YUHU SYDNEY ONE

TOWER B - MODIFICATION APPLICATION

17 JANUARY 2019
DRAFT
PREPARED FOR YUHU AWH GROUP

Figure 2 – Basement Allocation

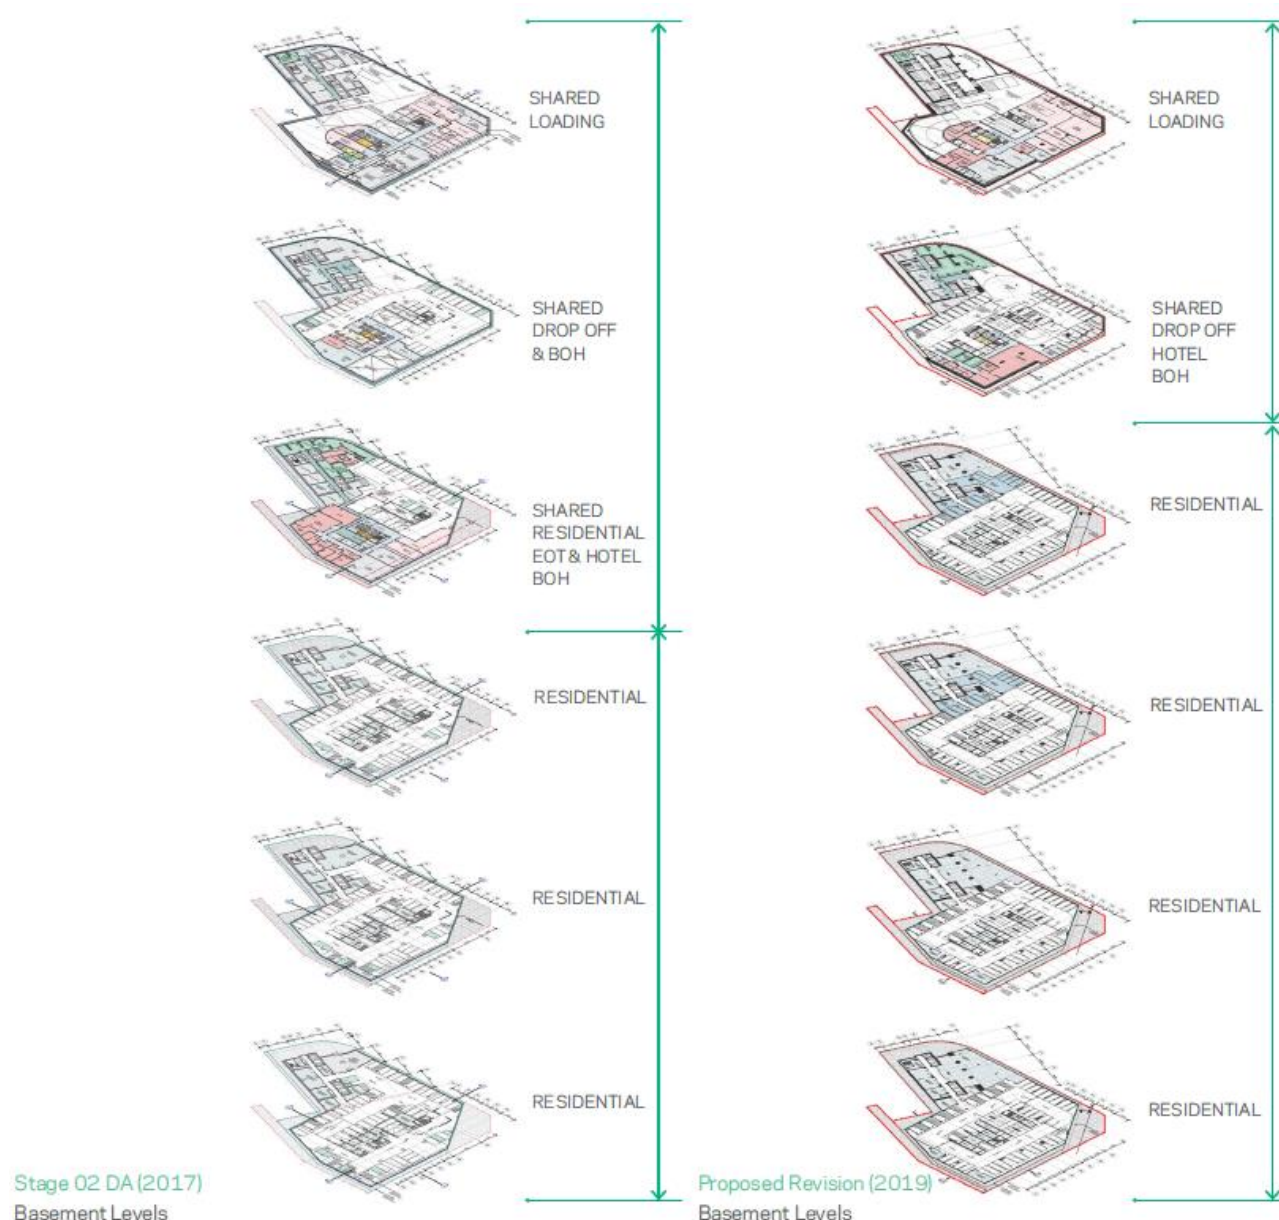
As illustrated in **Figure 2** below, the project retains six basement levels. Previously, basement levels 01 and 02 were shared between residential and hotel uses. Basement level 03 contained end of trip facilities (EOT), hotel BOH, and hotel parking. Basement levels 04 – 06 were used for private residential parking.

By reviewing the hotel BOH operations, basement level 03 was revised to be used exclusively for residential uses, simultaneously allowing for a more refined car park layout that is not constrained by turning circles and the tower structure layout. Basement levels 01 and 02 remain in principle similar to the previous DA application with minor alterations to accommodate the EOT and hotel BOH previously in basement level 03.

Figure 3 – Rationalisation of structure

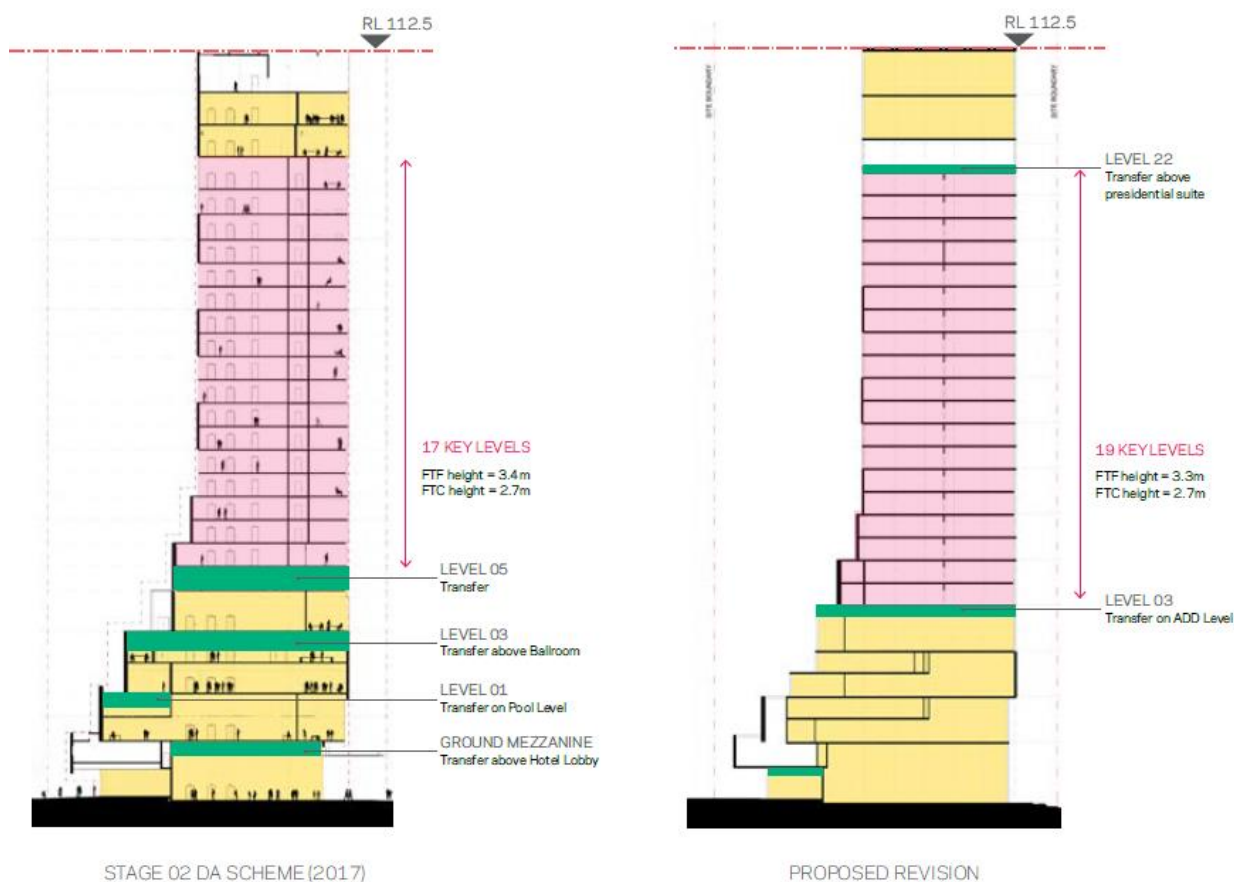
- On the typical levels, removal of two columns to the north east; and

- The number of transfer levels has been reduced as highlighted at Figure 3, and the floor to floor heights on the typical levels has been optimised, allowing two additional hotel room levels.

As a result of a rationalisation of column locations, at the ground level the entrance from Pitt Street and canopy has been marginally revised to avoid intrusive column locations.

Figure 4 – Reconfiguration of upper levels

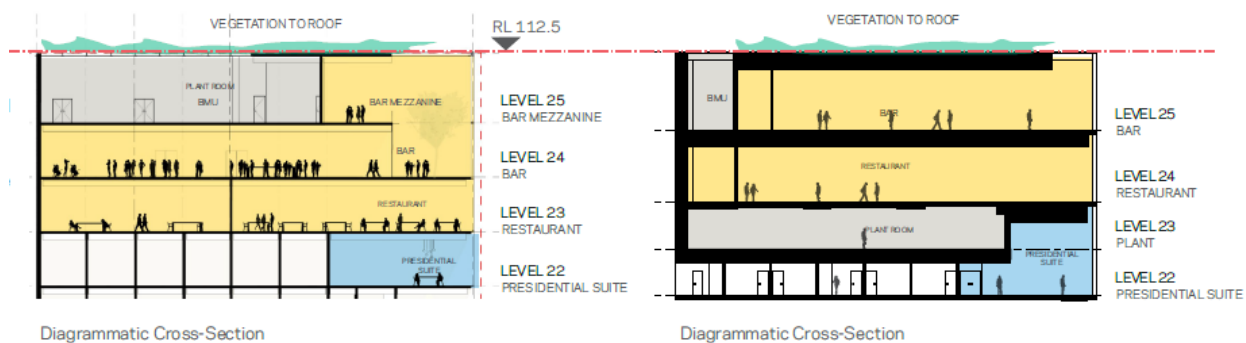
Relocating roof plant to Level 23 as shown in **Figure 4** provides an opportunity to create an unobstructed restaurant and bar area on the top two levels of the building. The rooftop bar will retain the operable roof to the north, which allows guests to experience the outdoors and Sydney climate within a protected environment.
